Royal Far West (RFW), Manly –Wind Conditions – Section 75W modification

Please find herein a brief letter detailing the expected impact of the changes to the proposed re-development at the RFW Campus, Manly, on the local wind climate. This letter has been prepared in regard to the proposed Section 75W modification of the Part 3A Concept Approval MP10_0159. The architectural drawings (Lodgement S75W drawing set, issue B, dated 14 July 2021) by Murcutt Candalepas, Figure 1, have been reviewed from a pedestrian-level environmental wind perspective.

Figure 1: Comparison between existing and proposed floor plans at various levels

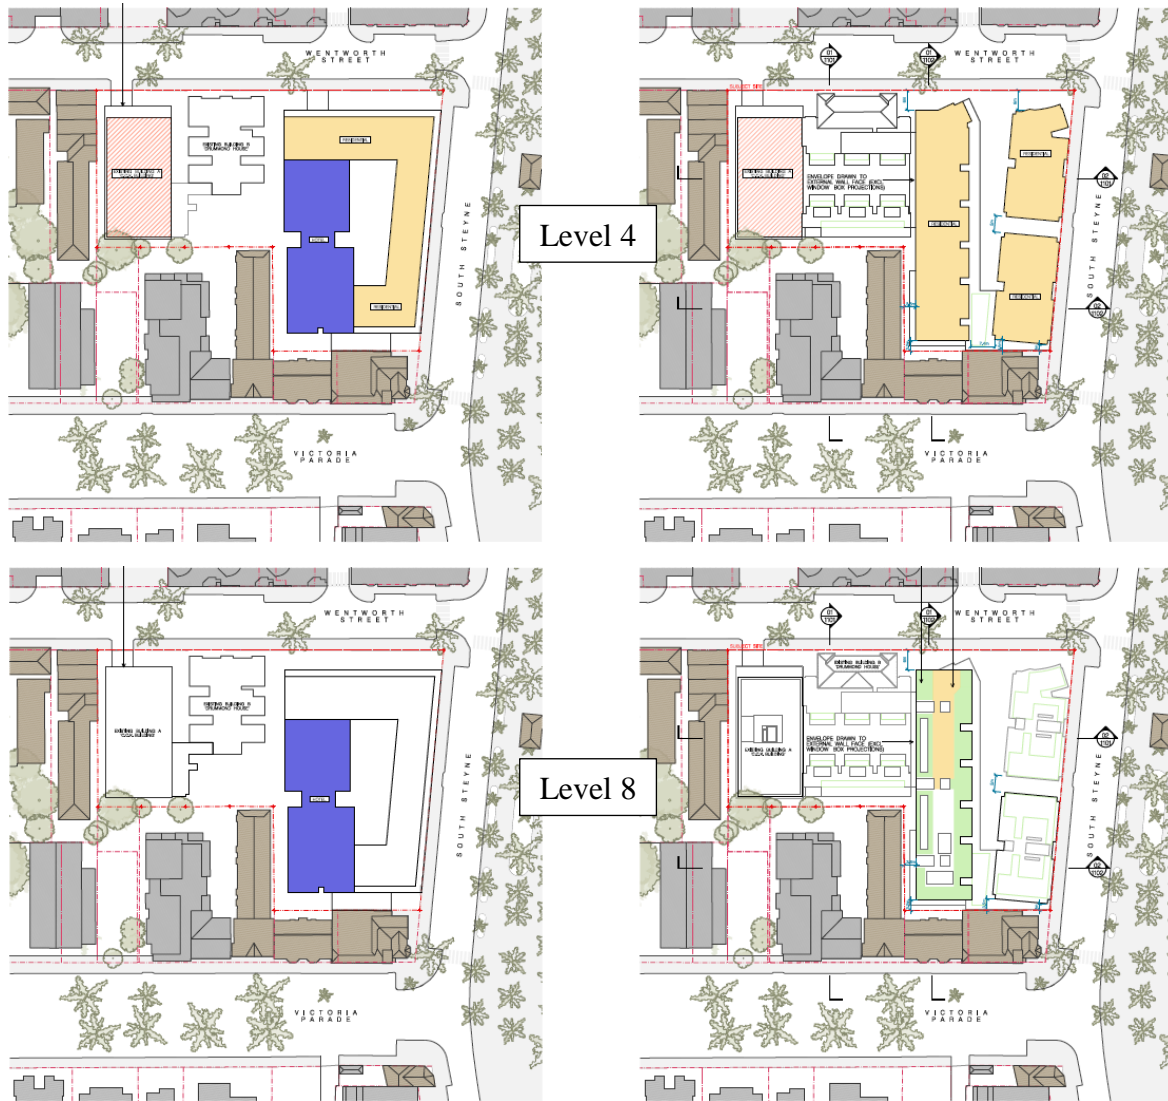
Winds from the north-east are the dominant prevailing wind direction for the site, as winds from the south and west are more shielded by upwind buildings. The major changes to the massing from a wind perspective are the semi-open undercroft to the east, the splitting of the massing of the east building to introduce a central open space, and the distribution of massing between the buildings. It is considered that these changes would have a small, but beneficial impact on the local wind environment at important locations. The opening of the undercroft and splitting of the east building, would reduce the acceleration around the corner of Wentworth Street and South Steyne for prevailing winds from the south.

All locations in and around the proposed development would be expected to meet the pedestrian safety criterion. From a wind comfort perspective, the compartmentalisation of the undercroft, with narrower and wider through-links, would reduce the impact of winds from the north-east accelerating through to the courtyard. The wind conditions through the undercroft would be suitable for transient use, if more sedentary activities are intended for these spaces, then additional landscaping or mitigation may be required.

The courtyard area to the west between the buildings is relatively well-protected for all wind directions, with the open undercroft encouraging more of a sea-breeze during hot-summer afternoons.

The wind conditions at the majority of locations around the perimeter of the site would be classified as suitable for pedestrian standing type activities, increasing in strength to pedestrian walking around the corners of courtyard entrances and within the undercroft. The more enclosed nature of the playground is a benefit to the site. The wind conditions around the site are considered to be suitable for the intended use.
